GREENVILLE UTILITIES COMMISSION

QUESTIONS AND ANSWERS II FOR PALLET RACKS, SHELVES AND INSTALLATION

#20-18, DUE, MARCH 25, 2020 UNTIL 3:00 PM (EDST)

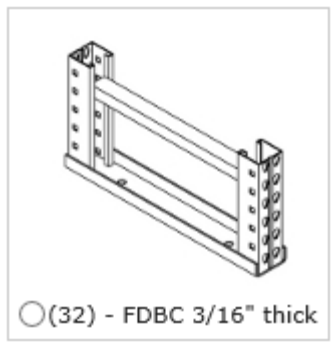
1. In the description provided in your packet for the base plates , there is not a side profile to view. My rack supplier is wondering if the following type of base plate would work (this example does not have the bullnose included):

If not, then we should be able to make the flat plates work.

A continuous base plate would be ok as long as when they shim there are no voids between the continuous baseplate and the floor.

That being said, there are issues with the image they sent:

- The base plate needs to have a minimum thickness of $\frac{1}{4}$ ".**
- The baseplate under the bullnose must be one continuous base plate for the front upright and the attached bullnose.**
- The image does not have a heavy horizontal transfer bar shown**
- The image appears to only provide one anchor hole near each upright**
